## ZONING COMMITTEE STAFF REPORT

1. **APPLICANT:** Shepard Development LLC **FILES #** 15-007994 and 15-022204
  2. **TYPE OF APPLICATION:** Site Plan Review and Variance **HEARING DATE:** 4/16/15

3. **LOCATION:** 1475 Davern St. (May be changed to 2751 Shepard Road in the future)
  4. **PIN & LEGAL DESCRIPTION:** 212823420016 Whitneys Re Arrangement Ofbe Vac Fairview Ave Adj And Part Of Lot 28 Steels Subd E Of 7th Blvd And In Sd Re Vac Wheeler St And Leonard Ave Alleys Accruing All Of Gertrude St E Of W L Of Lot 21 Blk 2 And Lots 16 Thru 3o Blk 1 Lots 21 Thru 3o Blk 2 All Of B

Site plan review for a new mixed-use development

Site Plan\*

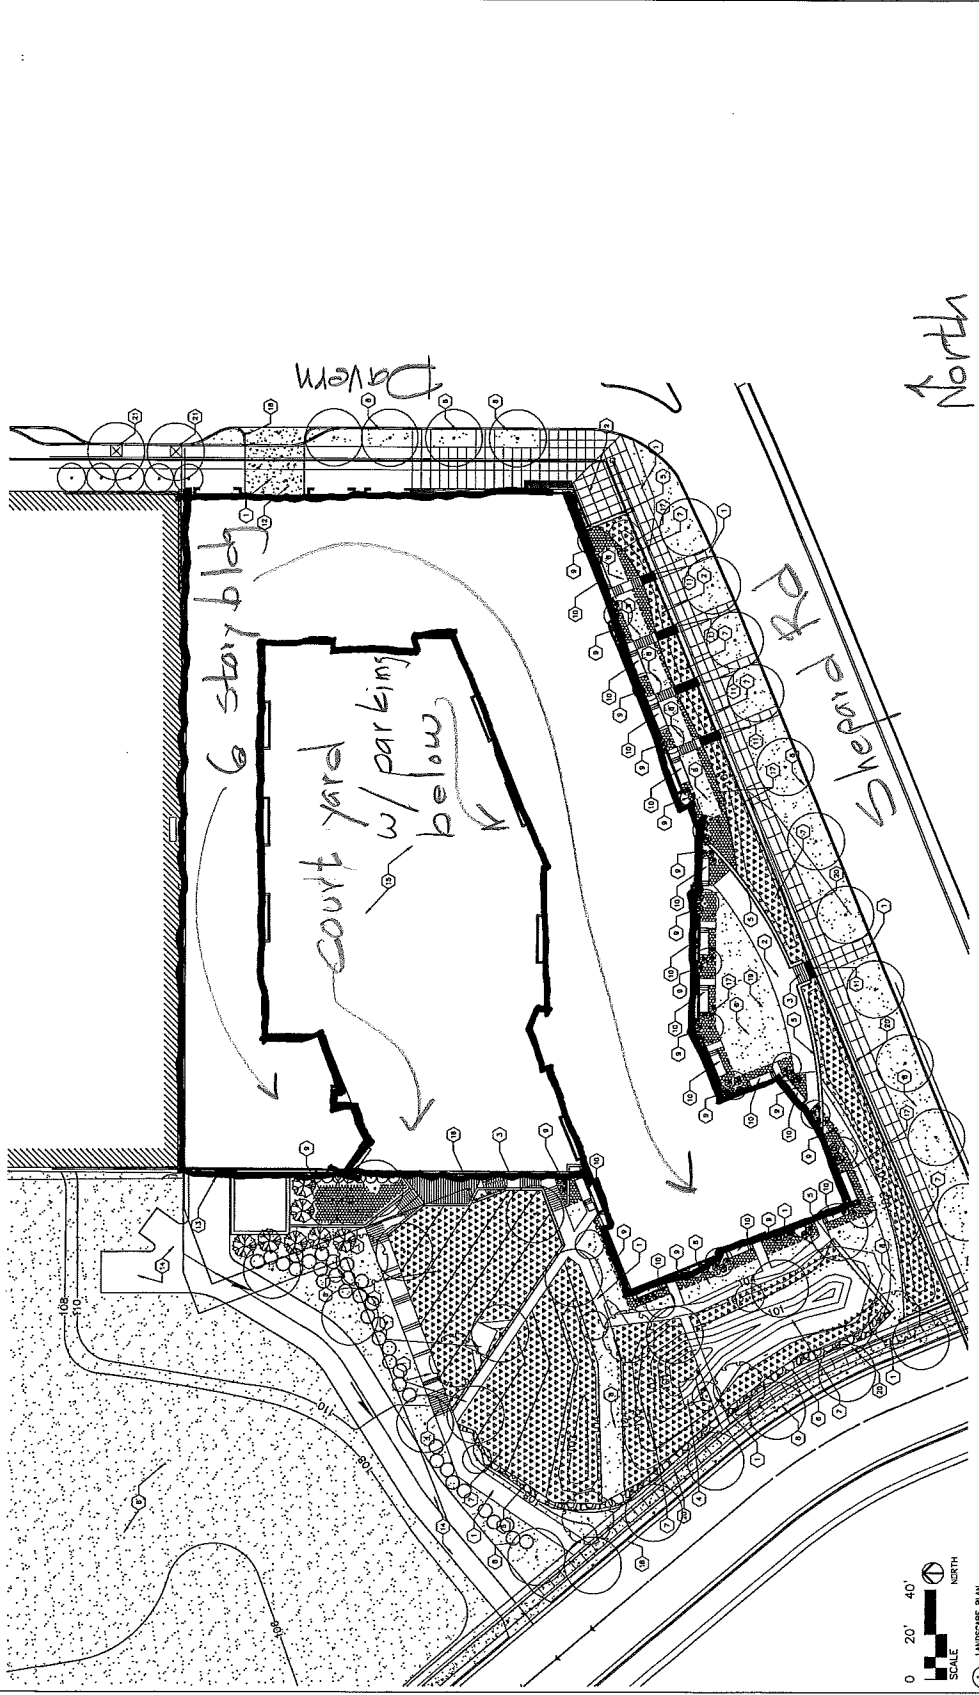
The proposed site plan shows surface water draining to a pond near S. Wheeler St., rain gardens along the Shepard Road sidewalk, and tree trenches running the length of the Shepard Road boulevard. These features all drain toward the Shepard-Davern intersection, where any overflow outlets to an existing storm sewer.

The south part of the roof appears to drain to underground tanks for an irrigation system. The rest of the roof and the amenity deck drain to tiered gardens on the west side of the building stepping down from the amenity deck toward the pond.

9. *Sufficient landscaping, fences, walls and parking necessary to meet the above objectives.* The site plan meets this finding. The application includes a detailed landscaped plan. Boulevard trees (five different species) will be planted on Davern, Shepard, and S. Wheeler. Sloped areas will be planted with a "native mesic prairie mix" and the boulevards will have turf. The building is set in groupings of ornamental trees, shrubs, and perennials. Many are natives that will support birds and bees. At this point, no detailed plan has been done for the amenity deck, which is mostly hidden from public view. The development would be a great improvement to the edge where the Great River Park meets the city.
10. *Site accessibility in accordance with the provisions of the Americans with Disabilities Act (ADA), including parking spaces, passenger loading zones and accessible routes.*

The site plan can easily meet this finding, and the applicant has indicated that the minor changes required will be made. The parking ramp for residents requires 7 handicapped spaces; only 6 are shown on the plan. The retail and visitor parking area requires one handicapped space; none is currently shown.

1. The building must be substantially as presented and illustrated to the Planning Commission, using materials that are the same or better.
2. Final approval by the Public Works Traffic Division.

3. Final approval by the Public Works Sewer Division.
4. Final approval by the Fire Department of adequacy of water supply for fire suppression sprinklers.
5. Before building permits are issued, the developer shall have an agreement with Saint Paul Parks and Recreation about a parkland dedication or a fee in lieu.

Section 4 (Height Study)

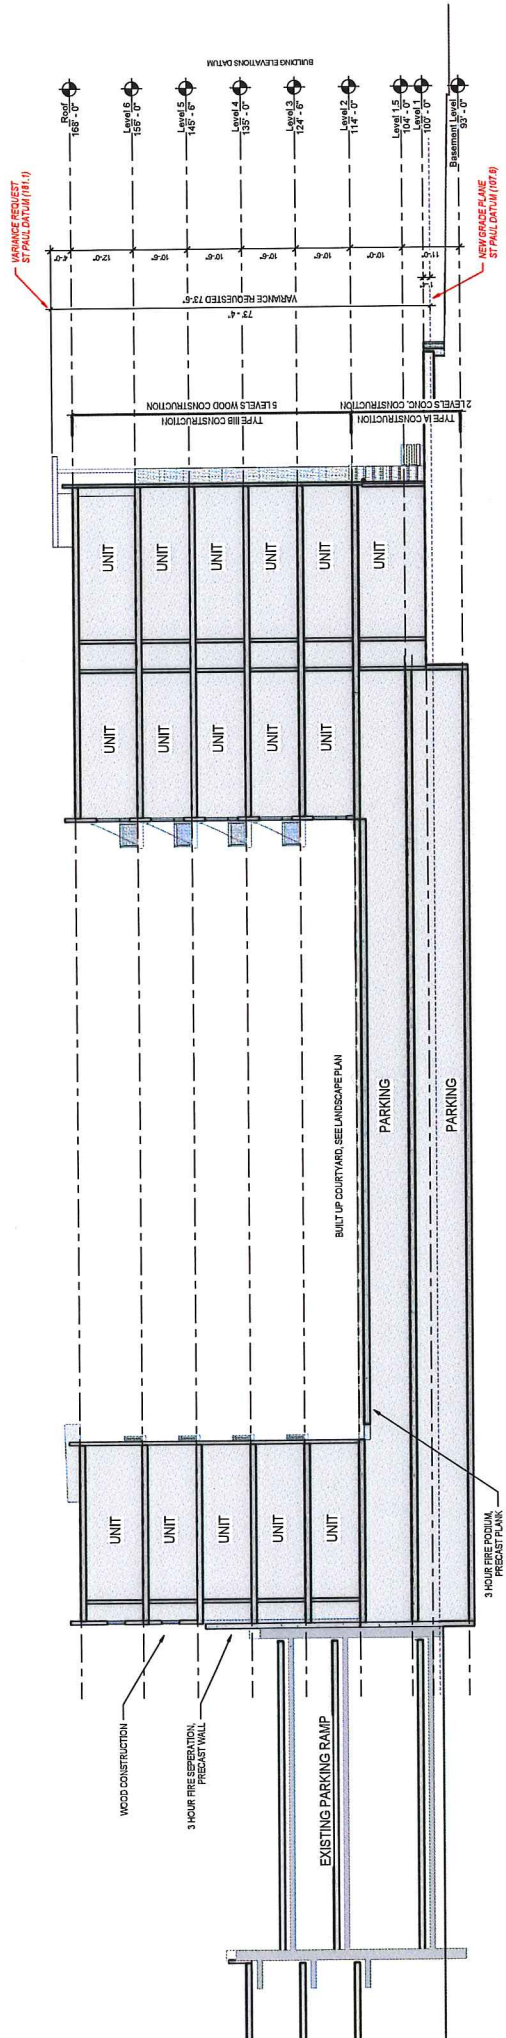
*Height:* Maximum height in T3 is 55' for a mixed use building; maximum height in RC3 River Corridor overlay zone is 40'. The proposed building is 73'4" high and exceeds these height limits. The developer has applied for a height variance. The variance request is covered on pages 8 to 10 of this staff report.

This finding is met. In the T3 district, heights greater than 55' feet are allowed through either increased setbacks or conditional use permits, except in the river corridor (MRCCA) overlay district. The proposed height is generally consistent with similarly situated buildings along Shepard Road and with other buildings within approximately one half-mile that were constructed on similar shallow bedrock sites.

We are request a variance to the height of 73.5' from average grade plane (107.6' Saint Paul Datum)\*, an 18.5' variance from 55'. The concealment of the south face of the existing parking structure and additional site improvements are being done to offset the impact of the building to the neighborhood.

1. The bedrock of the site of phase is between 3'-4' below grade. This does not allow for the parking levels to be constructed below grade. The two parking levels are partially buried (-2.5') but require (18.5') feet above grade. All building parking occurs within the enclosed parking levels, no surface parking. (Note: we are not using the existing garage to park this building.)

A. PHASE 1 SITE SECTION - THROUGH PHASE 1 BUILDING & MISSISSIPPI RIVER

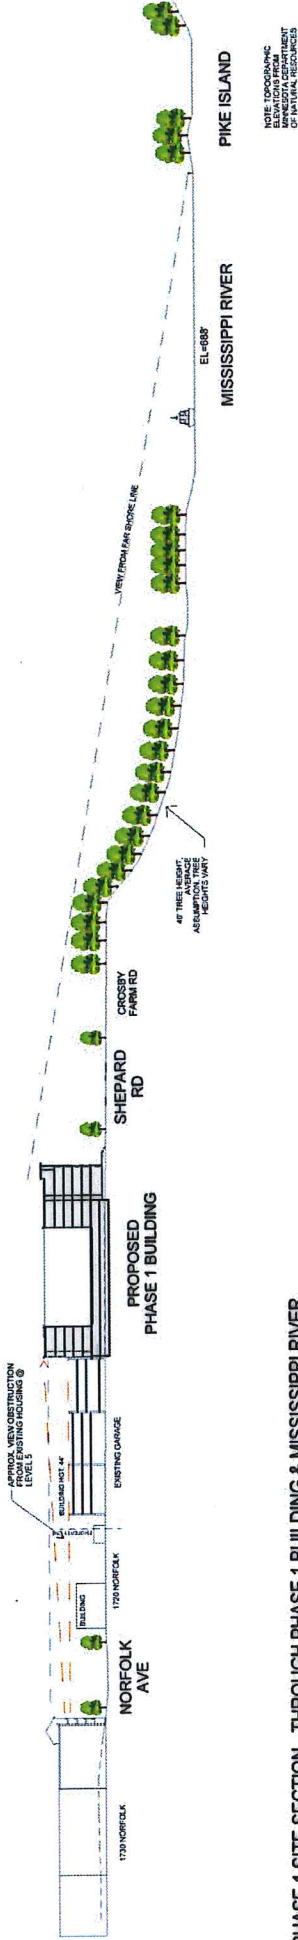
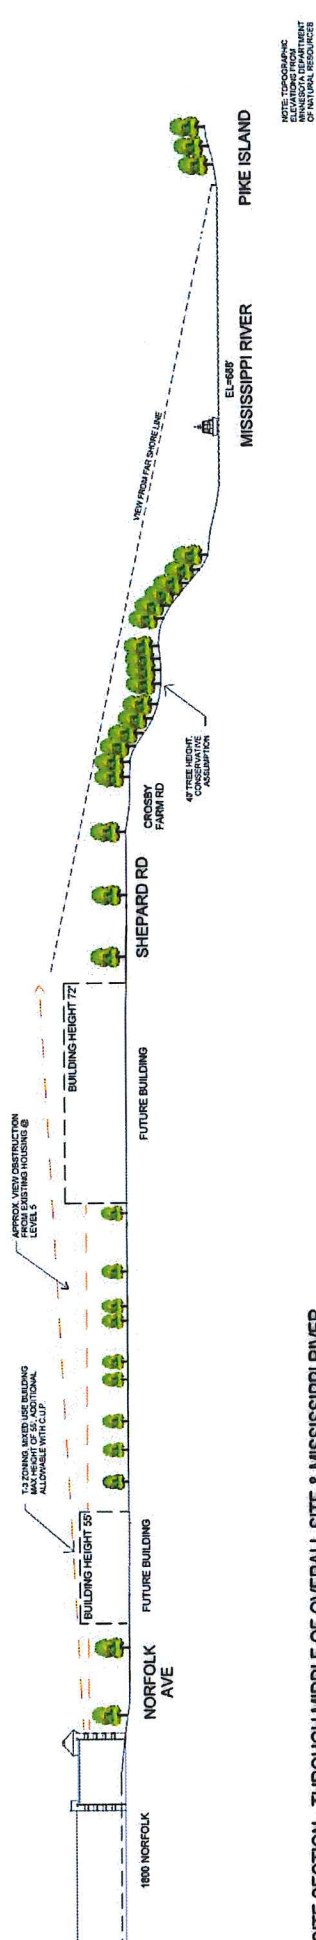
*River Corridor Views.* The building would have minimal visual impact on the river valley. The applicant submitted a cross section illustration of the river valley and bluff in relation to the proposed building. The building would be visible from the Saint Paul river bluff, which is directly across Shepard Road from the site. It would not be visible from the northern shoreline. During the months when leaves are on the trees, the building would not be visible from the river itself, and would be barely visible from Pike Island's trails. Pike Island is a quarter to half a mile away on the river bottom.

The Shepard Development Phase 1 building is requesting a variance for height. The phase 1 building faces site and financial hardships that are difficult to overcome. Beyond the site constraints the additional height would add much needed density to help offset the development hardships. The site is in the process of officially being zoned T-3, which allows for 55' for a mixed use building. Additionally the site is located with the RC3, river corridor overlay district. RC3 guidelines limit development height to 40', additional height can be achieved with a conditional use permit. Through coordination with city planning staff it was established that this project will be reviewed as T-3 zoning for height, recognizing the updating zoning for the site. Therefore we are applying for a variance only and not a conditional use permit. The additional approved height will have negligible impact upon the river corridor. See Exhibit E for river corridor sections and cross shore site lines.

The additional height requested has minimal impact on the neighbors and broader neighborhood. Additionally the building height will be shielded from views across the Mississippi River shore line, see attached exhibits.

**View of Shepard-Davern area from Mendota Heights church**

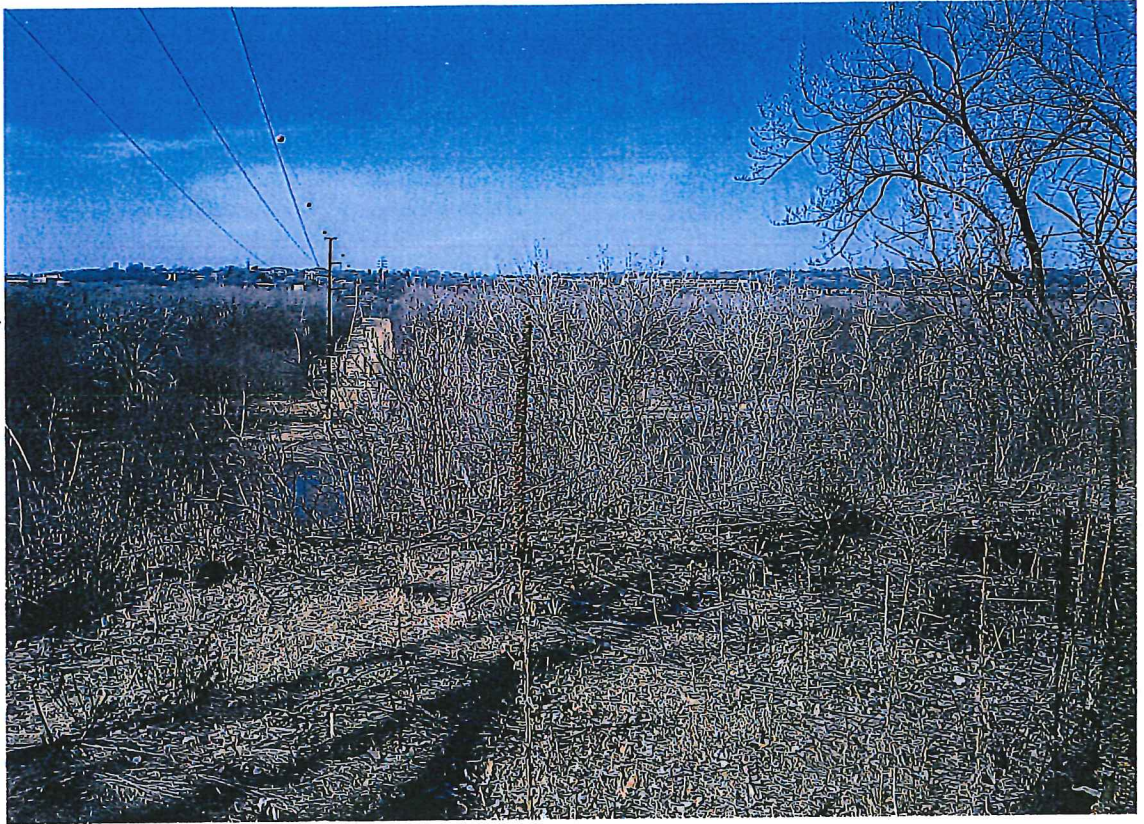
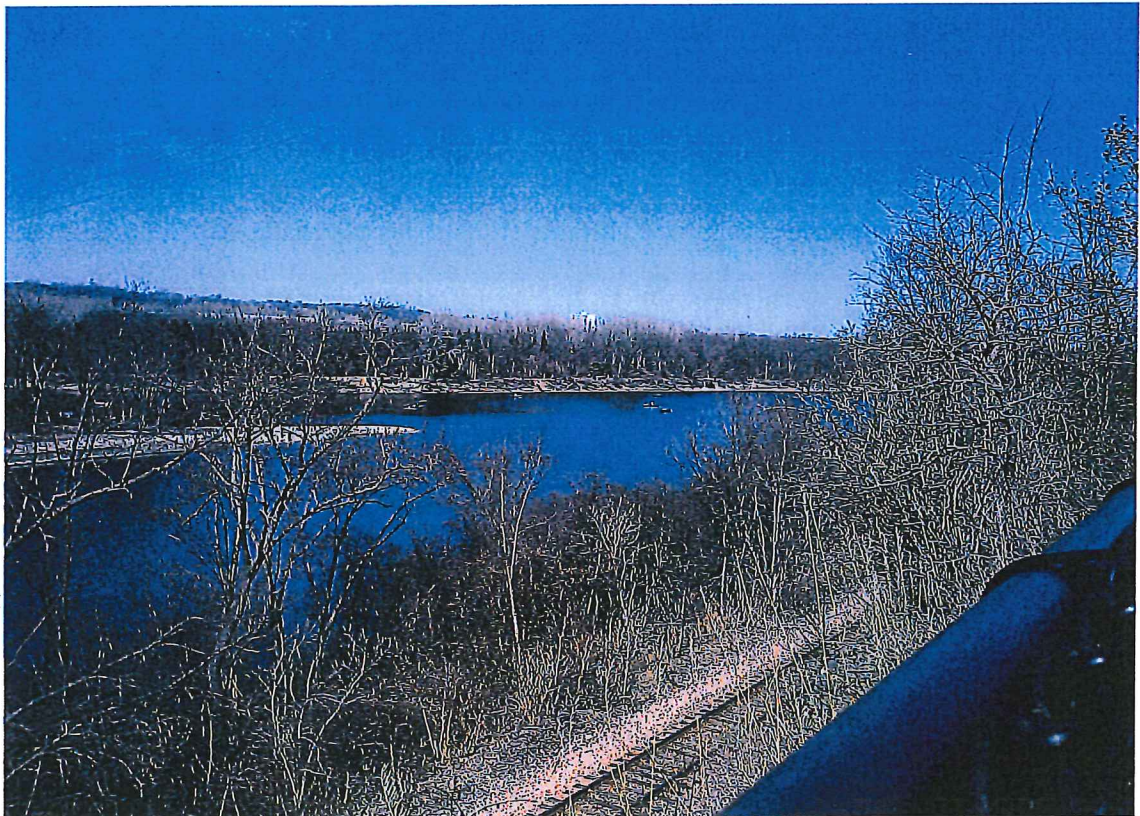
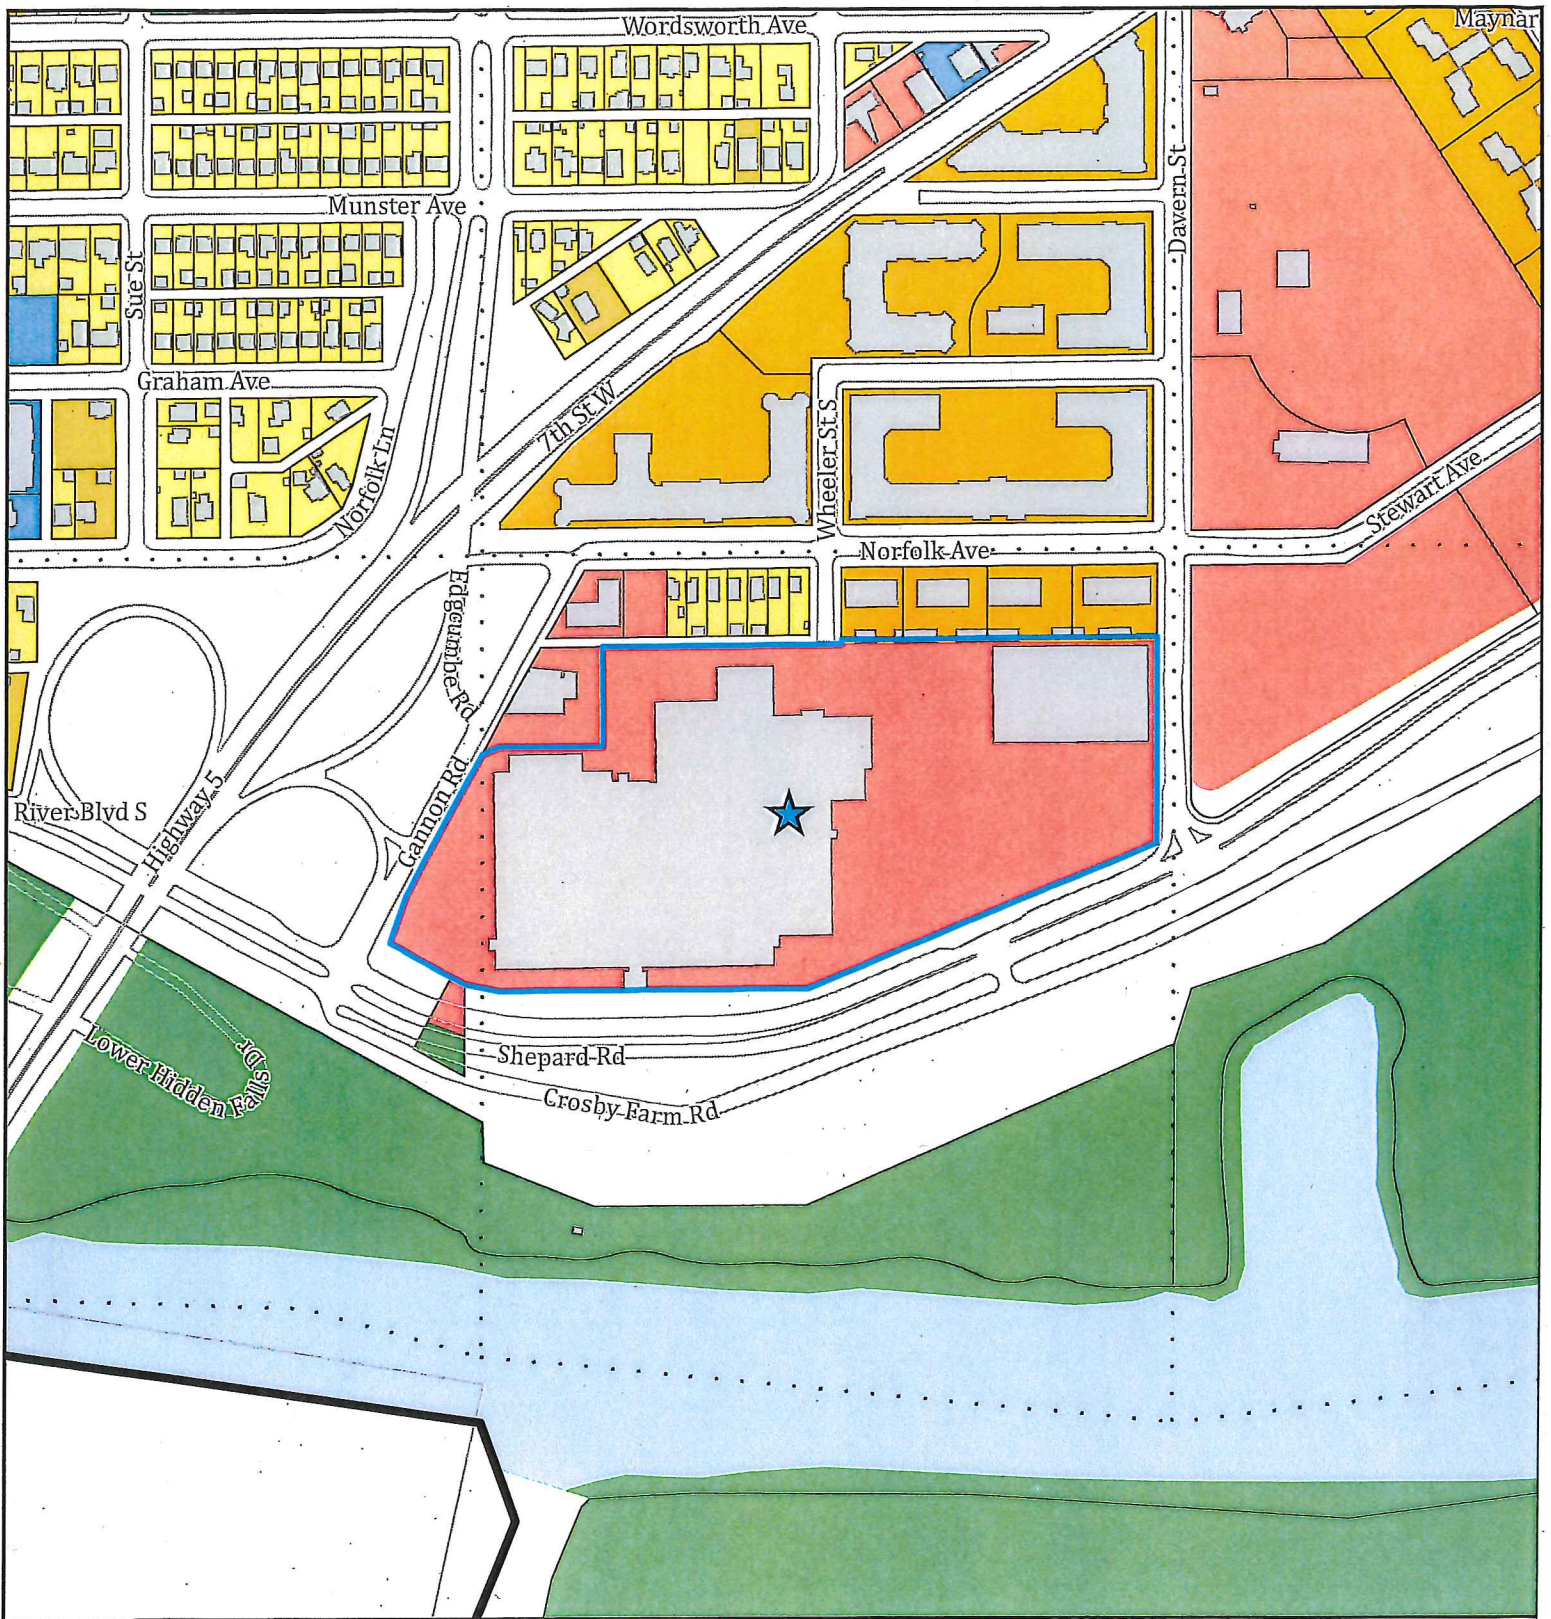
From Fort Snelling across the river to the west, the Shepard-Davern area is not visible from within the fort because the view is blocked by the barracks. It is only visible from the tower. The view is partially obscured by trees, but the top floors of the proposed building would be visible. The tower is half a mile away.

The site is intermittently visible from across the river in Mendota. Highway 13, running near the bluff, is three-fourths of a mile away. When viewed from across the river, Shepard-Davern lies within a panorama dominated by the green of the river valley with ribbons of urban development at the crests of the bluffs on both sides. The proposed building would become another small part of this ribbon on the bluff crests.

Several photos are attached showing views of the site from different vantage points.
